Comments of the Keweenaw Bay Indian Community in Opposition to the Issuance of an Underground Injection Control Permit to Kennecott Eagle Minerals Company (Application No. MI-103-5W20-0002)

Prepared for:
Keweenaw Bay Indian Community
16429 Bear Town Road
Baraga, MI 49908

Ann S. Maest
Stratus Consulting Inc.
PO Box 4059
Boulder, CO 80306-4059
303-381-8000

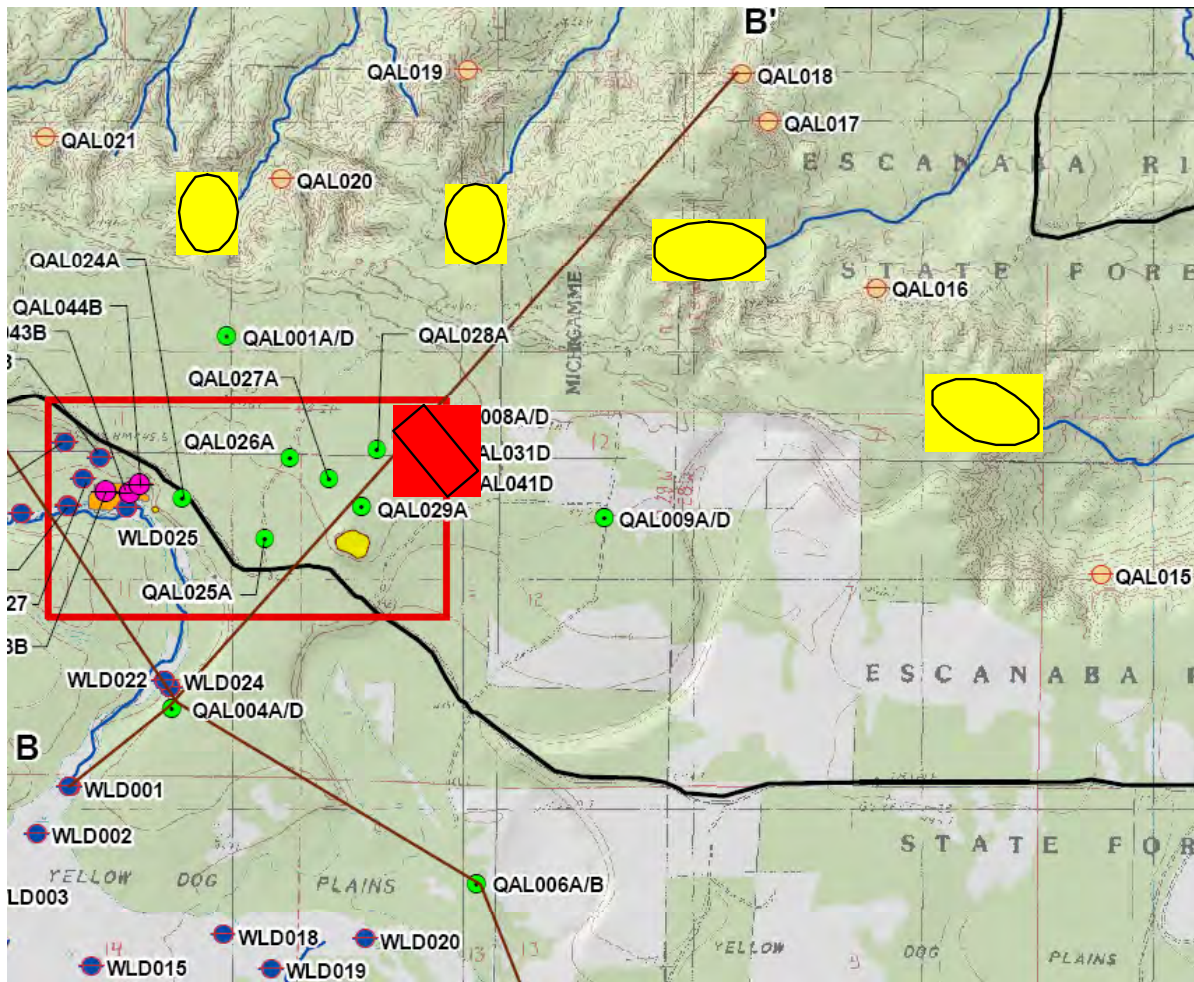
The most significant flaw in KEMC's characterization is the lack of any boreholes or monitoring wells between the TWIS and KEMC's presumed surface water venting locations to the northeast (Figure 4.1 – yellow highlighted areas are possible venting locations) As a result, no geologic cross-sections were provided to U.S. EPA, as required for a UIC permit application, that clearly describe all saturated and unsaturated zone stratigraphy from the point of discharge at the TWIS in the direction of groundwater flow. The only cross-sections that KEMC provided (Figure 4.2) are to the southwest of the TWIS, which is in a direction exactly 180 degrees from KEMC's proposed northeast groundwater flow direction.

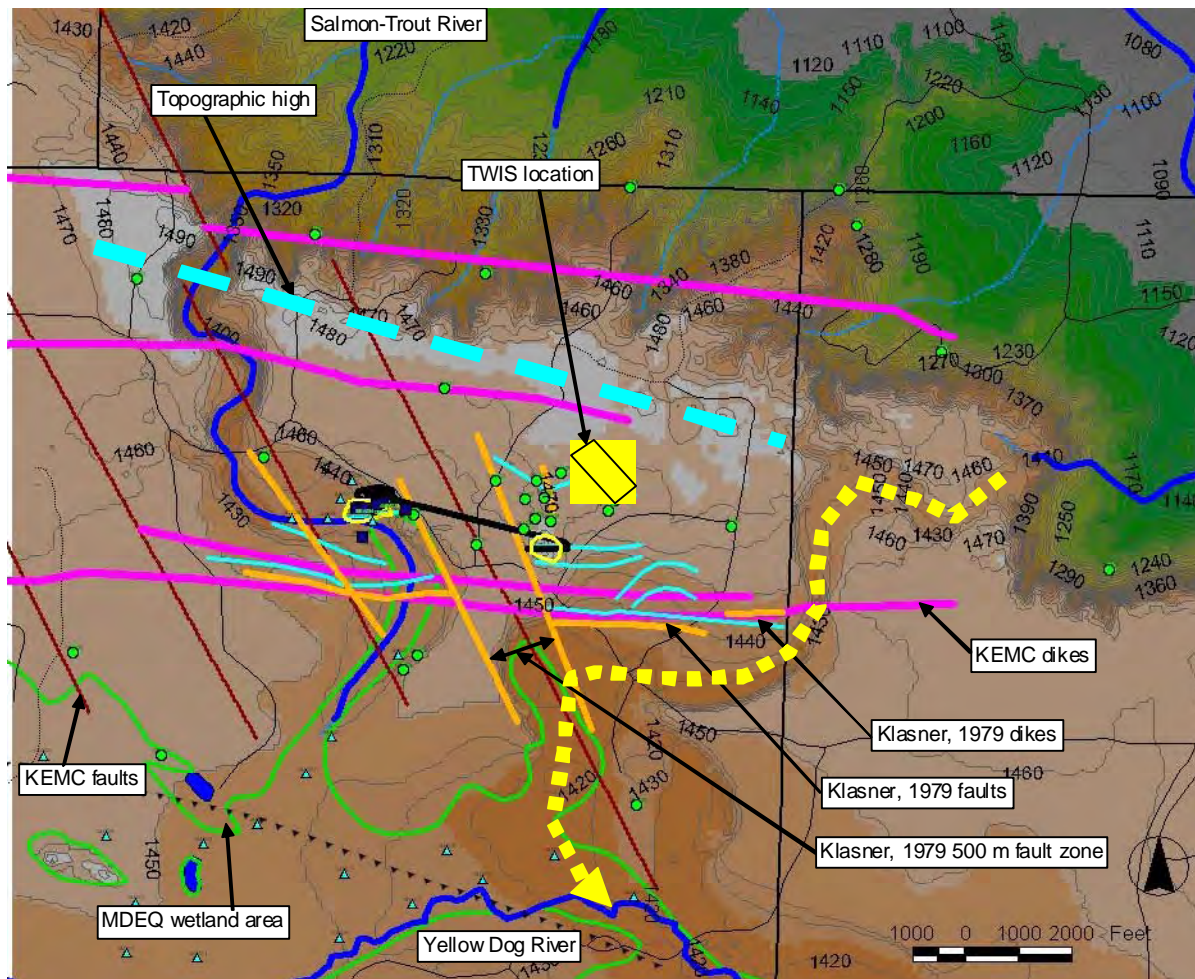
To better coordinate the available structural information in the TWIS discharge area, we synthesized it in a geographical information system (GIS) (Figure 4.4). This figure shows the traces of large structural features (i.e., faults, dikes, fault zones, and topography) relative to the TWIS. Several points can be made about the mapping of structural faults/dikes:

- ▶ There is a clear lack of characterization of geology in the fault zone area due to the lack of boreholes/wells (green dots).
- ▶ A dike (shown as a light blue line) runs right beneath the TWIS area (Klasner et al., 1979). However, KEMC did not acknowledge this or attempt to study its possible effect on groundwater flow.

- ▶ Klasner et al. (1979) map faults (orange) along dikes (light blue), yet KEMC did not investigate the very likely occurrence of preferential groundwater flow within brecciated zones along the edges of dikes (particularly those north of the TWIS). Intrusion of these dikes likely caused elevated bedrock areas. Flow across dikes is typically very low, due to the low permeability of these features, so it is very likely that groundwater flowing north/northeast from the TWIS would be realigned similar to the dike orientation (to the east).

- ▶ A major surface drainage feature immediately east and south of the TWIS drains into wetlands (green lines in Figure 4.4) south of the TWIS and eventually into the Yellow Dog River. Although this feature starts at the northern edge of the Yellow Dog Plains, it does not drain immediately north into the Negaunee Moraine area, but instead drains south and westward. This is nearly opposite to the direction KEMC presumes for natural groundwater flow from the TWIS. This feature is more pronounced (i.e., broader and deeper) than the Salmon-Trout River, and nearby wells demonstrate that the feature acts as a local drainage feature for the underlying shallow aquifer system. This major surface

Figure 4.5. Isopach of Quaternary deposit (ft) in the TWIS area.

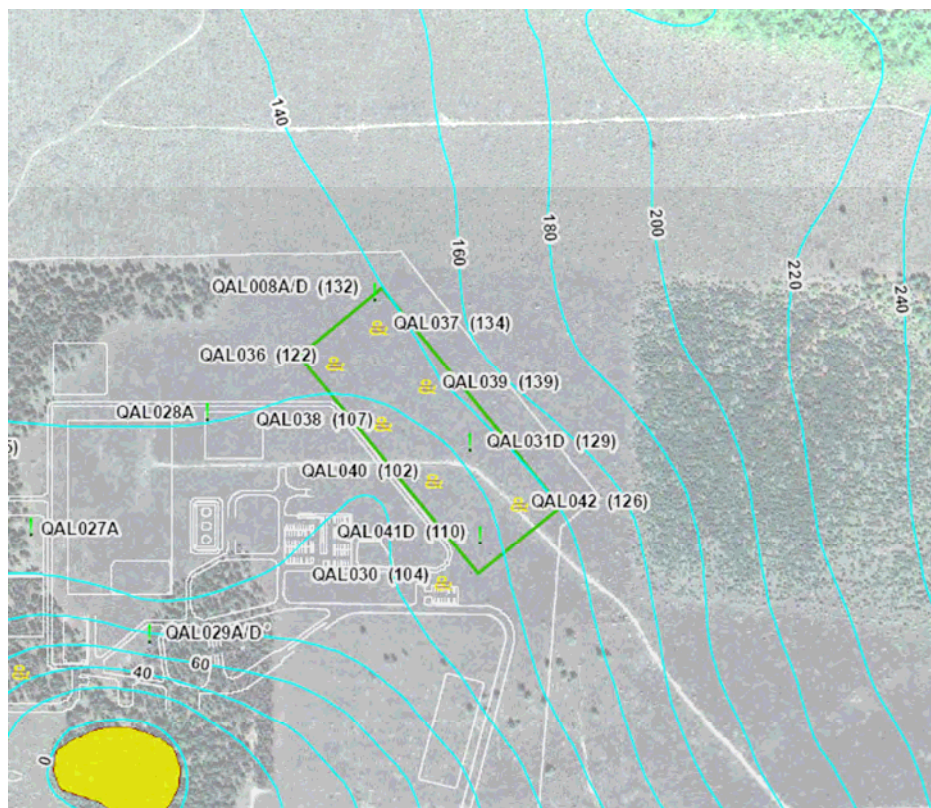
The isopach (i.e., thickness) map of Quaternary deposit (Figure 4.5) shows thickness dramatically increasing in the TWIS area. KEMC stated that the thickness of the Quaternary deposit generally increases towards the northeast (Foth & Van Dyke, 2006b, App. B-8, p. 27). However, it is clear from Figure 4.5 that the thickness instead increases dramatically to the east. This trend strongly suggests that groundwater flow directions are oriented in a similar direction to increasing Quaternary deposit thickness, rather than the presumed northeast direction. Such a change in groundwater flow direction would significantly change KEMC's predicted surface water venting locations and the impacted USDW area. U.S. EPA should require greater investigation of the hydrogeology of the TWIS area because of the large uncertainty in groundwater flow direction.

- ▶ KEMC prepared plots of Quaternary isopach thickness, which require wells drilled to bedrock, using control points like well QAL032 (Foth & Van Dyke, 2006a, App. B, p. 142). However, the log for this well does not show that bedrock was ever encountered in the borehole.

- ▶ KEMC shows bedrock contours extending just north-northeast of the TWIS (Foth & Van Dyke, 2006b, App. B-8, Figure 17). However, no attempt was made to investigate how far this critical structural feature extends north of the Yellow Dog Plains watershed and down into the Negaunee Moraine.

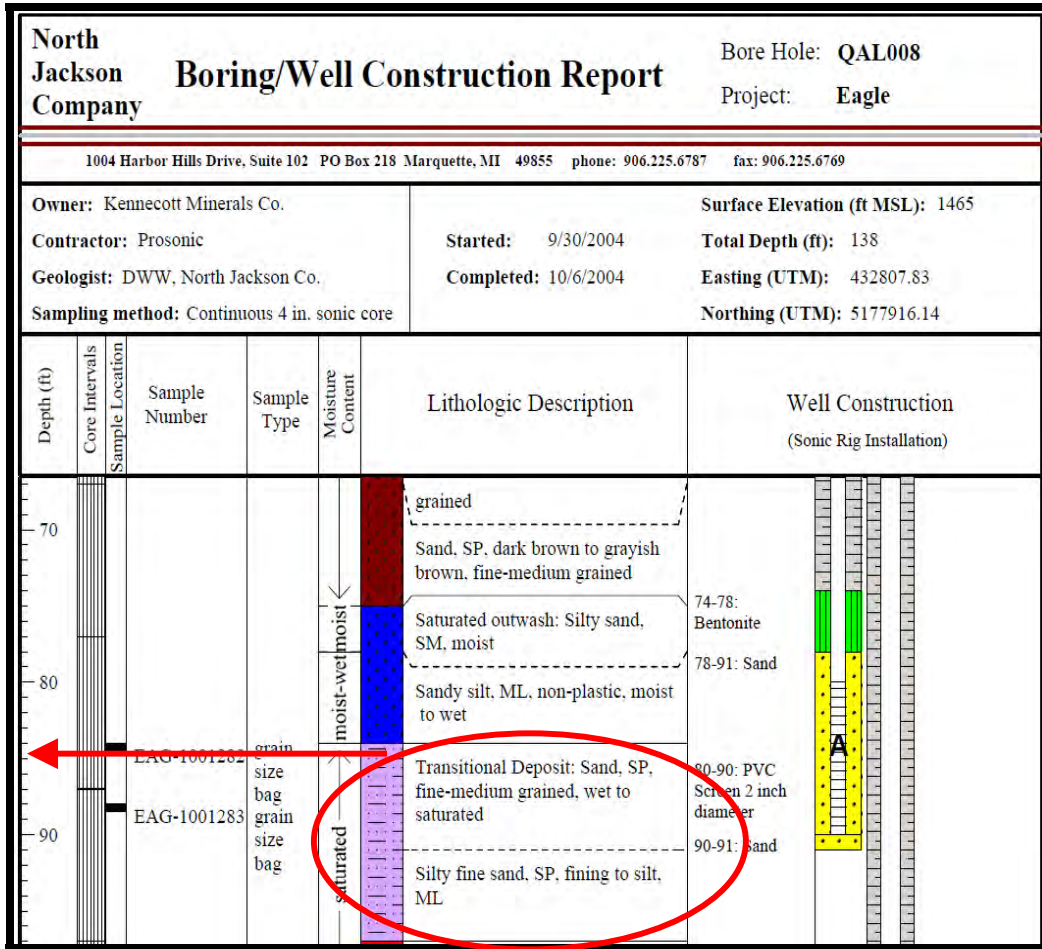
- ▶ Figure 4.7 shows the geologic log for borehole QAL008. The information in the log clearly shows the presence of low permeability strata (silty sand, sandy silt) from ~ 75 to 85 ft bgs. This information is not reflected in KEMC's cross-section using borehole QAL008, shown in Figure 4.8. The purple stratum shown in the cross-section (fine sand silt and clay) should have been shown as a more continuous layer that included borehole QAL008.
- ▶ Most TWIS borehole logs (031, 037 to 042) showing silty sand at various depths above the water table were given the same graphical symbol as the sand. This is misleading because it suggests that this material is hydraulically equivalent to sand. These silty sand zones occur above the B and C zone (purple and red colored areas) shown on Figure 4.7 in areas denoted as "unsaturated sand" (brown areas).

Figure 4.8. Cross-sections E-E' and F-F' through the TWIS.

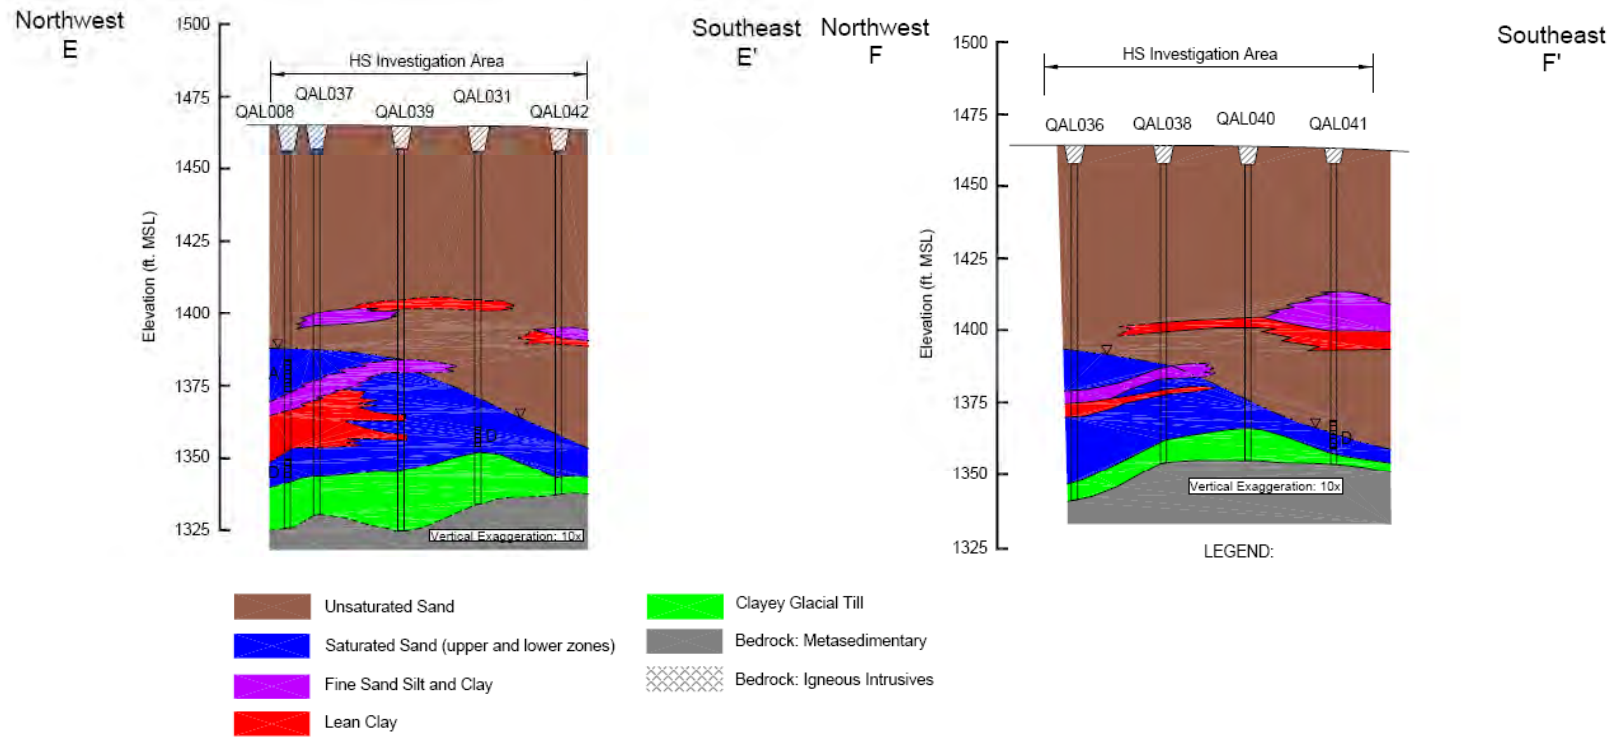
- ▶ Borehole 031 shows “fine silty sand” at 37 ft bgs; 042 shows “silty sand” at 36 to 38 ft bgs; and 041 shows “silty sand” from 30 to 45 ft bgs. No attempt was made to correlate these shallow unsaturated zone silty sands across cross-sections E-E’ and F-F’ (see Figure 4.8), yet they will act as significant barriers to infiltration of TWIS discharge to the groundwater table.

- ▶ The borehole log for well 040 shows sandy silt (SM) from 68 to 80 ft bgs, yet on the cross-section F-F’ no silt is shown in this zone above the water table (see Figure 4.8). Instead this zone is defined on the section as sand.

- ▶ The borehole log for 039 shows SC (clayey sand) for the USCS code, but this is inconsistent with the geologists’ description of sandy clay, which has a USCS code of CL, or clay. Again, this information is shown incorrectly on cross-section E-E’. For example the SC is shown in the saturated zone and does not correlate with the lean clay (red in Figure 4.8).

Figure 4.9a. A-zone aquifer groundwater elevation contours. The red arrows show KEMC's interpreted groundwater flow direction (to the northeast). Newer maps by KEMC show groundwater flow to the east/southeast, as shown in Figure 4.9b. The TWIS is located near the base of the second arrow.

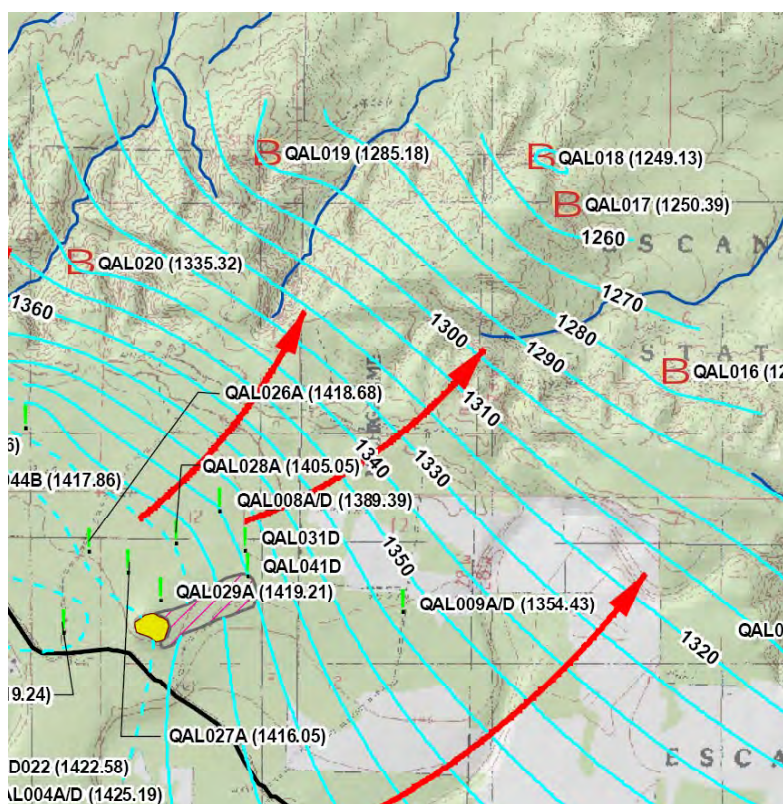
- ▶ Groundwater contours for the A zone shown on Figure 4.9a are too high by more than 30 ft near springs (along streams). Note that the groundwater contours are drawn straight across deeply incised streams on the northern part of Figure 4.9. Like topographic contours, groundwater elevation contours should "point" upstream. Therefore, at the points where the blue groundwater contours cross the streams, the actual groundwater elevation is substantially lower.

- ▶ Groundwater elevations are drawn above the ground surface where they cross deeply incised streams. It is possible for groundwater heads to be higher than the ground surface if the aquifer is confined or under artesian conditions. However, KEMC has stated that the aquifer at the TWIS is unconfined (Foth & Van Dyke, 2006b, App. B-8, App. C – Aquifer Hydraulic Testing Data), so the groundwater contours should reflect actual water table elevations.

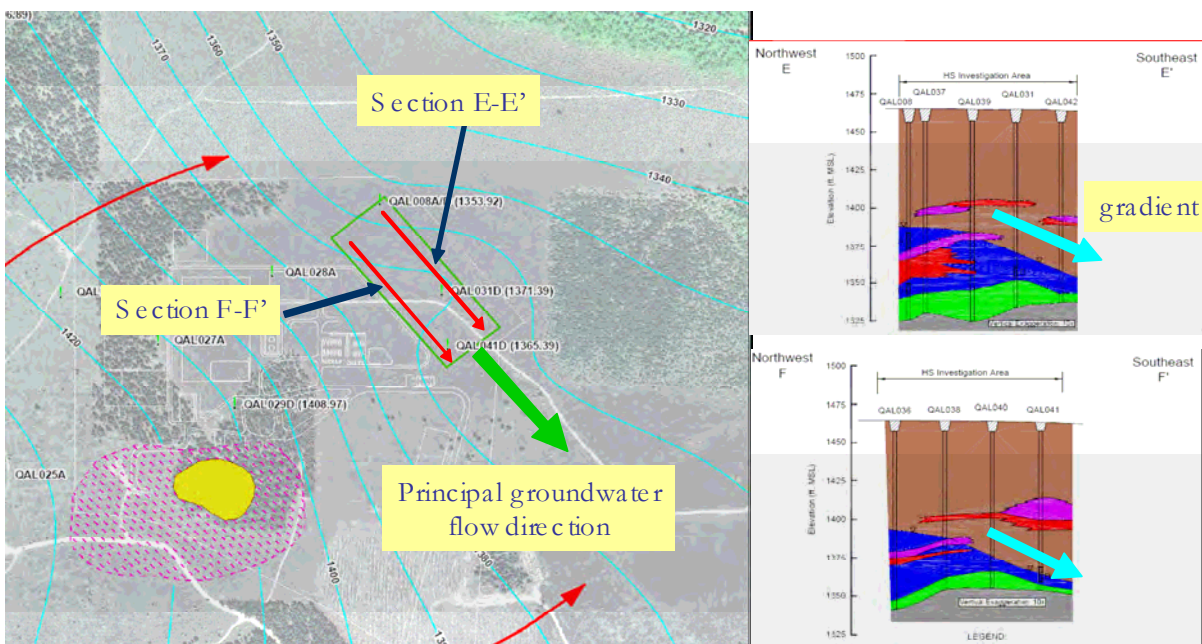
- ▶ Groundwater elevation contours are inconsistent with gradients shown on sections E-E' and F-F' (Figure 4.10, right). Cross-sections E-E' and F-F' clearly show much larger gradients (0.034-0.037) to the southeast (shown on the cross-sections) than to the northeast (~ 0.02) (shown on the groundwater contour maps).

Figure 4.11. Groundwater elevation contours for the D zone aquifer and dikes (thicker light blue lines) mapped by Klasner et al. (1979). Red lines are KEMC's inferred groundwater flow directions in the D-zone aquifer.

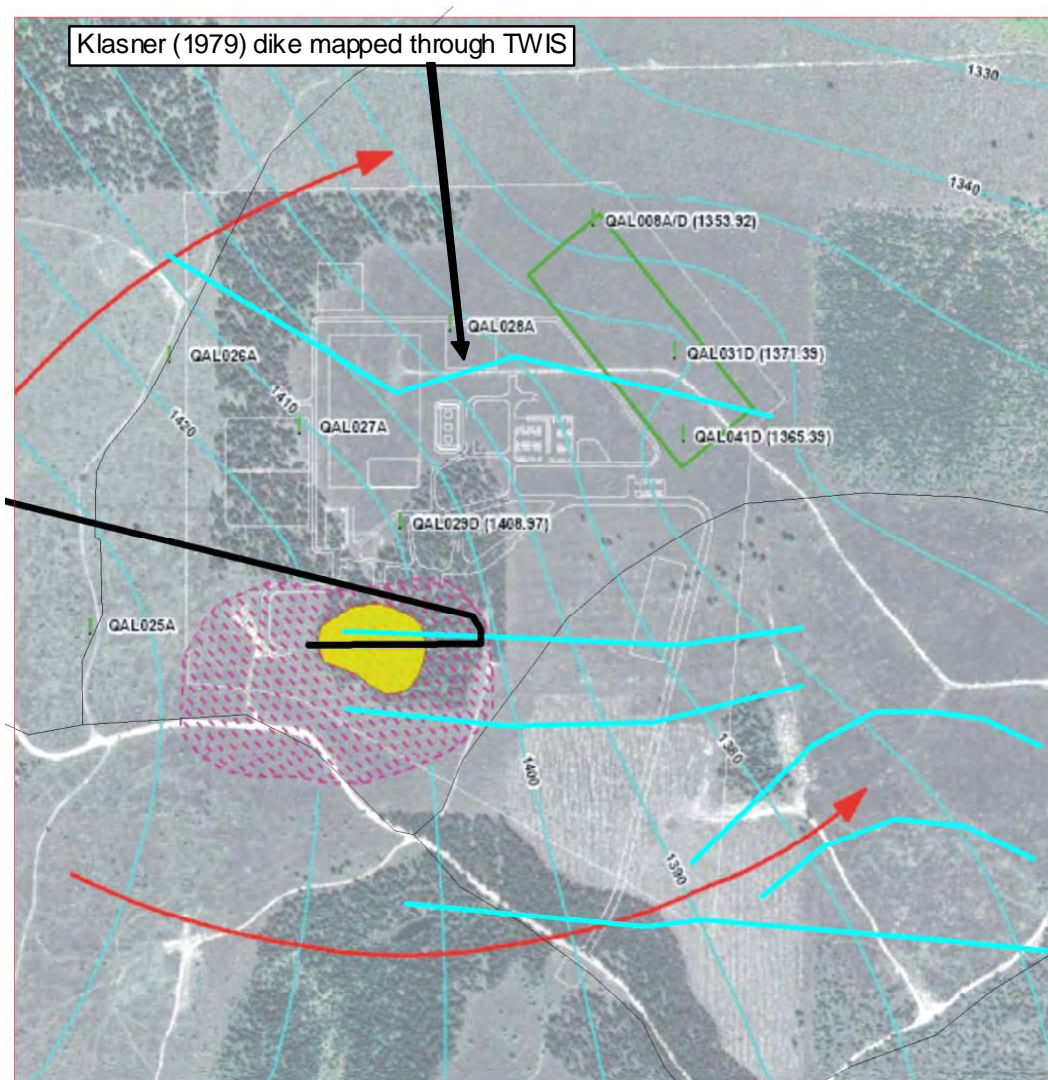
Figure 4.11 shows the same D-zone aquifer groundwater levels from Figure 4.10 and the approximate locations of dikes (from Klasner et al., 1979, shown as thicker light blue lines). Klasner et al. (1979) mapped one dike directly beneath the TWIS that is shown as ~ 2,500 ft long and oriented northwest to southeast. This dike may explain the abrupt change in groundwater levels below the TWIS (represented by the squiggle in the contour lines under the TWIS). The strong southeastern groundwater gradient shown on cross-sections E-E' and F-F' (Figure 4.10, right) is consistent with the orientation of this dike to the southeast. Higher permeability in the brecciated zone along the dike could drain groundwater from the D-zone aquifer toward the southeast and explain the drop in groundwater elevations.

Figure 4.12. Generalized conceptual flow model for the TWIS discharge area and downgradient area, as proposed by KEMC – looking northwest.

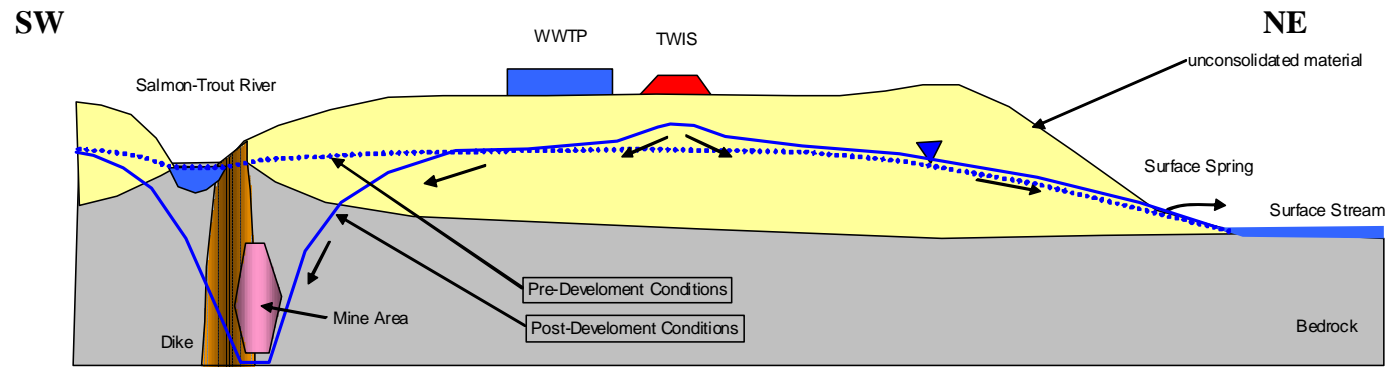
KEMC adopted an overly simplistic conceptual flow model for the TWIS area that shows flows moving to the northeast, despite inconsistencies with observed data. Figure 4.12 shows the generalized groundwater flow conceptualization proposed by KEMC.
